Addendum No. 02

File Reference Number: RFP 2026 035

Title: Timmins Interior and Exterior Bus Garage Upgrades

RE: Clarifications/Questions

WINDOW TYPES

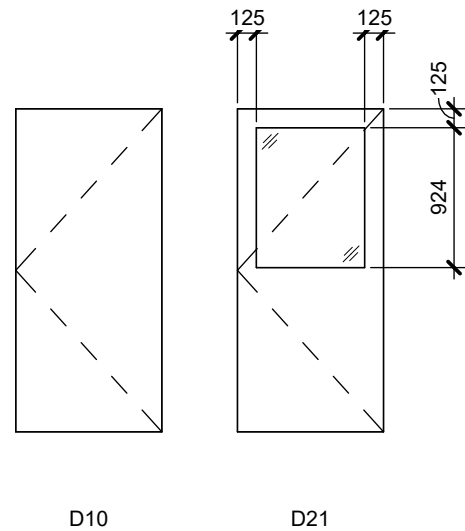
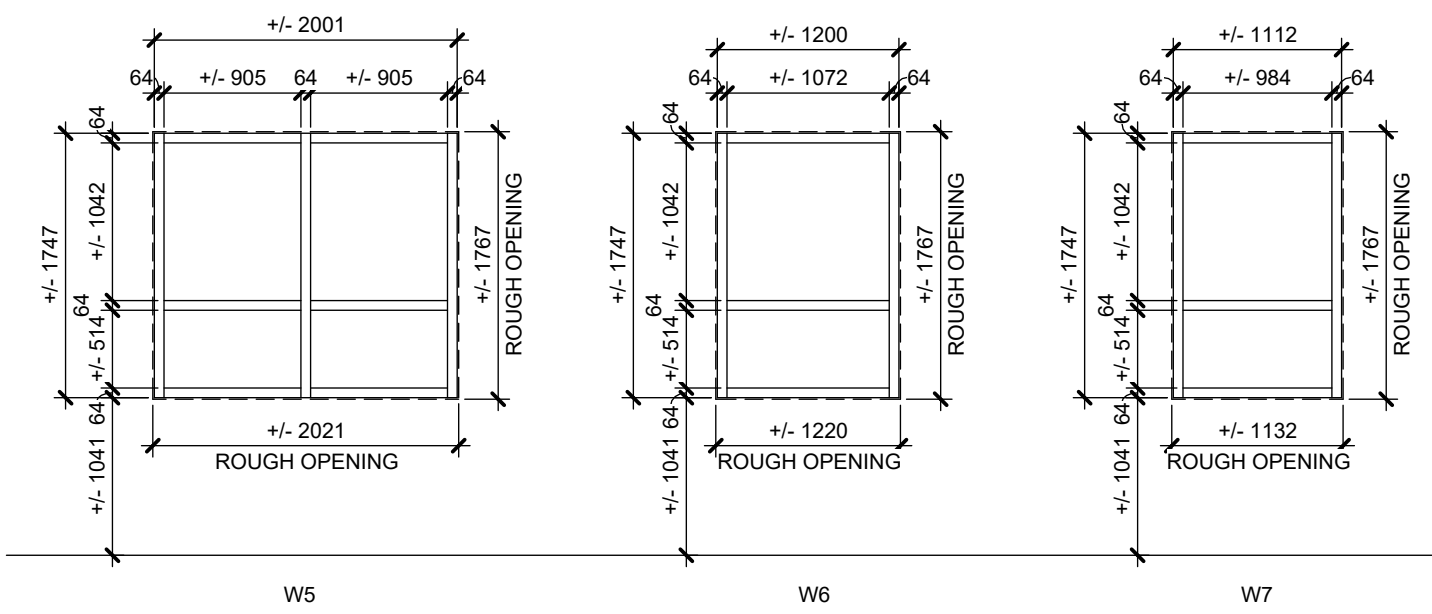
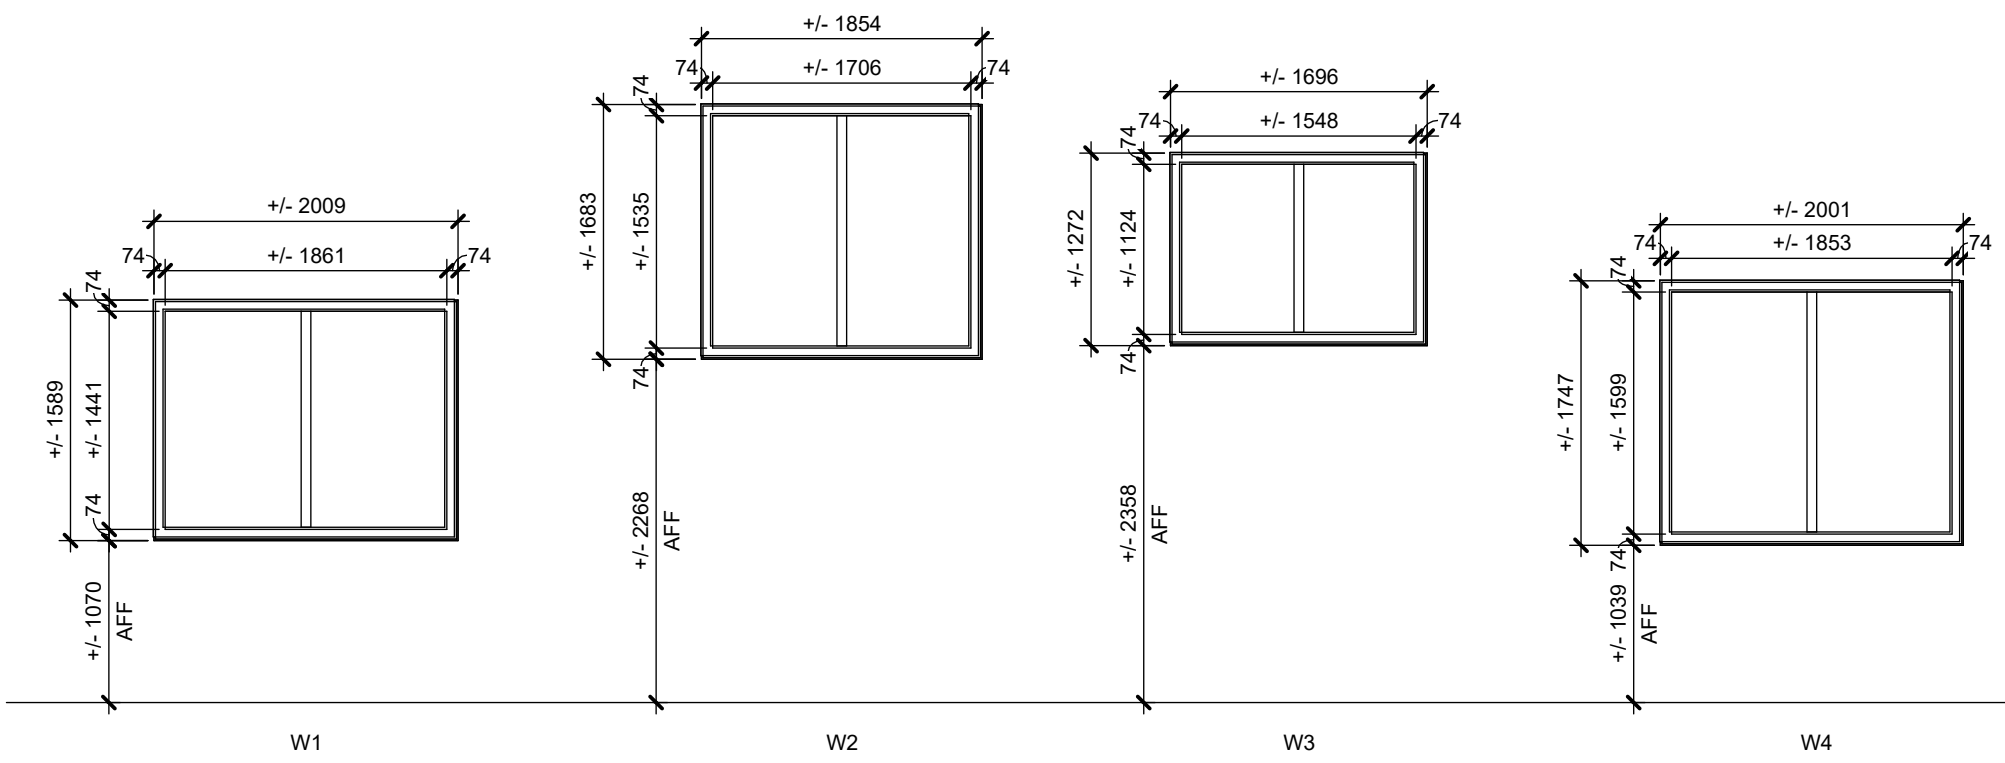
Item 9: Please confirm glazing specifications as well as the locations of W5-7 as they cannot be found.

Answer: Glazing specifications shall be in accordance with Specification Section 08800 – Glazing. Please refer to updated drawings A002, A204, and A301, which have been revised to include the correct window types and tags on the floor plan and elevations. These drawings have been provided at the end of this Addendum at Appendix A.
